DEVIATION REQUEST AND DECISION FORM

Project Name :	FLYING HORSE NORTH (SF2326)
Schedule No.(s) :	6136000005, 6136004037, 6136003004, 6136000003
Legal Description :	THREE TRACTS OF LAND BEING A PORTION OF SECTION 36, TOWNSHIP 11 SOUTH, RANGE 66 WEST OF THE 6 TH PM

A deviation from the standards of or in Section **2.3.2** of the Engineering Criteria Manual (ECM) is requested.

**TYPICAL MODIFIED URBAN RESIDENTIAL LOCAL
CROSS SECTION**

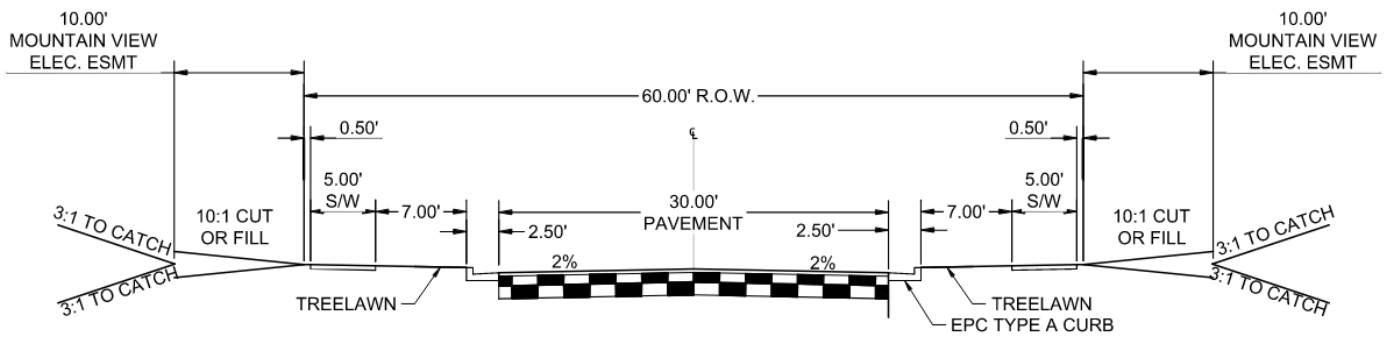
2.3.2 Design Standards by Function Classification, Table 2-7
The TIS estimates an ADT for the future developed condition for parcels that access/utilize Allen Ranch Road in this filing requires an urban section. A Typical Urban Residential Local roadway follows Standard Detail 2-2 which is a 50' ROW with a 30' paved section, concrete curb and gutter, and attached 5' sidewalk. The proposed modified section in the Construction Drawings for Filing No. 3 between the existing termination point of Allen Ranch Road (beginning of Filing No. 3 boundary and Parcel Sch. No. 6136000003) is deemed appropriate by the TIS to meet traffic criteria. The section is a 60' ROW with a 30' pavement section, concrete curb and gutter, 7' tree-lawn, and 5' sidewalk with MVEA easement on both sides just outside of the ROW section.

This modified urban residential local cross section is proposed as a section that achieves the roadway design intent to accommodate the estimated traffic ADT count in this particular stretch of roadway for the ultimate build out condition of Allen Ranch Road which, from this stretch of roadway, includes development of the Flats west of the roadway and full development of the 50 residential estate lots in Filing No. 3. North of this roadway section is required to be standard urban residential collector roadway should a future commercial development be developed – this is not proposed as a part of Filing No. 3.

The alternative is the standard typical section the County provides in the ECM Appendix F (Detail SD_2-2) per Chapter 2.3 criteria. The proposed modified section has been approved in other such rural developments that have mixed use areas that require urban sections with ADT counts that do not necessarily require a full collector roadway section of 36' pavement width. This section keeps a consistent public ROW width as the roadway transitions from urban local to rural local within the filing.

The standard urban local roadway per table 2-7 is a 60’ right-of-way and a 50’ right-of-way is allowed if 5’ public improvement easements are provided.

There is a need to transition from the rural local (28’ pavement width) to an urban local (30’ pavement width) in the proposed stretch of roadway for the modified section, then to the anticipated urban collector roadway (36’-48’ pavement width) due to the future commercial development to the north near Old Stagecoach Road. The proposed modified section includes detached sidewalk to better align with the future detached sidewalk of a future collector cross section due north. The proposed modified section facilitates stormwater conveyance to proposed Pond A with stabilized drainageways (curb and gutter) and storm infrastructure for collection and conveyance directly into the detention facility. As the commercial development to the north at the existing Golf Club House is not currently defined with a Site Development Plan, planning for a rural to urban transition in this area will better align with the anticipated need for a commercial collector roadway that will accommodate any set of proposed commercial developments within the commercial area as opposed to assuming a small rural section that would require improvements and reconstruction in the future.

The deviation will achieve the intended result with a comparable design by meeting the roadway’s traffic criteria and keeping a consistent pavement transition width and ROW width. There will not be a sudden widening from a 50’ urban local ROW section to a 60’ rural local ROW section and the proposed section allows for ease of transition from concrete curb and gutter to ditch sections.

This request has been determined to have met the criteria for approval. A deviation from Section 2.3.2 of the ECM is hereby granted based on the justification provided.
